<b>VESTEL ELEKTRONİK A.Ş.</b>	<b>CHANGE BULLETIN (TCN)</b>	<b>CHANGE NO: 69 REF NO : UMB 1370</b>
-----------------------------------	----------------------------------	--

**AFFECTED MODELS: ALL AMERICAN NTSC MODELS WITH 11AK26 CHASSIS.**

**REASONS OF CHANGE: WRITE PROTECTION CONTROL OF IC502 (EEPROM).**

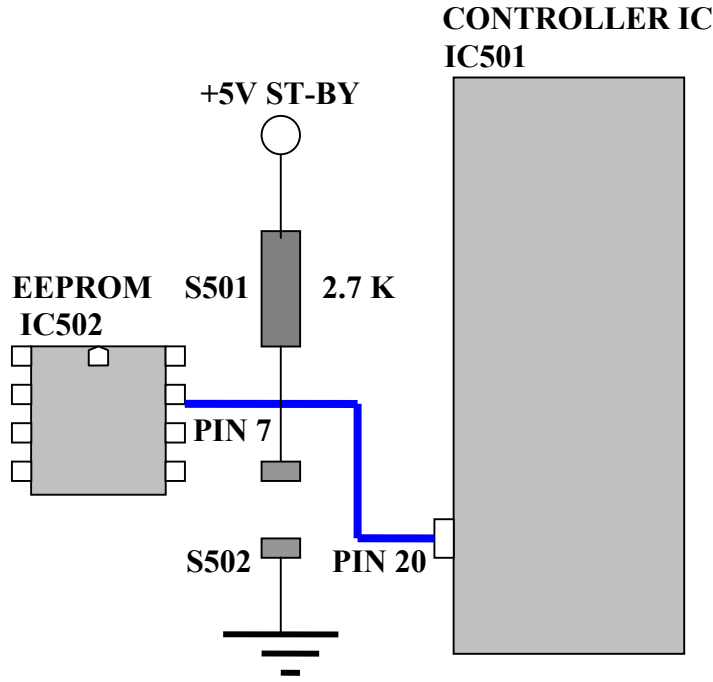
**NOTE 1: The cable (6 cm.) must be connected between the Pin 20 of IC501 and Pin 7 of IC502 under the PCB.**

OUT

NO	PCB CODE	VESTEL CODE	COMPONENT NAME	POSITION NUMBER	QUANTITY
1	11AK26	30001734	JUMPER SMD 0805	S502	1

IN

NO	PCB CODE	VESTEL CODE	COMPONENT NAME	POSITION NUMBER	QUANTITY
1	11AK26	30000631	RES SMD 1/10W 2K7 J 0805	S501	1
2	11AK26	30009834	CABLE BLUE 0.6MM	NOTE 1	1
